SUBJECT: An application for Bridle Gate, including a Revised Environmental

Impact Report, Vesting Tentative Subdivision Map, and Design

ALTERNATE VESTING TENTATIVE SUBDIVISION MAP

Figure 2: St. Regis Avenue and San Jose Avenue EVA

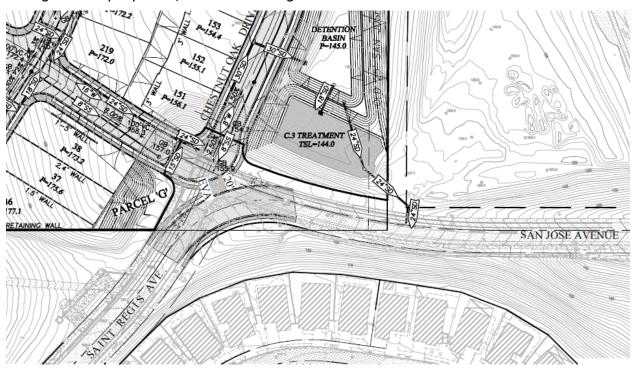
#1: St. Regis Avenue and San Jose Avenue EVA

The Alternate VTSM allows the streets internal to the subdivision (San Jose Avenue and Chestnut Oak Drive) to connect, but provides no connection to San Jose Avenue or St. Regis Avenue outside of the project boundaries. San Jose Avenue and St. Regis Avenue would maintain their existing connection. A 20-foot wide connection between the two roadways providing access to emergency vehicles would be provided, which would also allow bicycle and pedestrian access. This EVA, and the new roadway configuration proposed, is shown in Figure 2 below.

Figure 4: Single Park

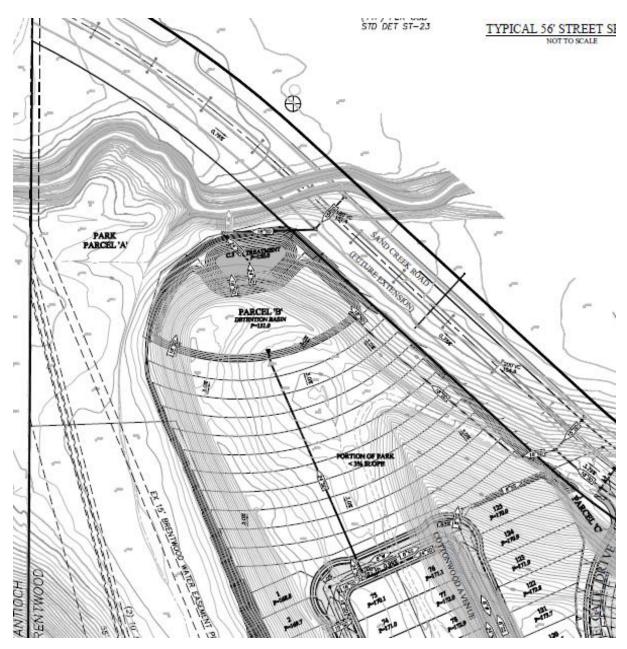
#3: Single Park

The Alternate VTSM combines the two original parks (6.0-acre Parcel A and 2.49-acre Parcel G) into one 8.49-acre parcel (Parcel A) in the northwest corner of the subdivision. The proposed single large park results in 4.35 acres of useable park space with less than three percent slope, consistent with the amount of parkland required based on the population expected to be generated by the project. The single park is shown in Figure 4 below.
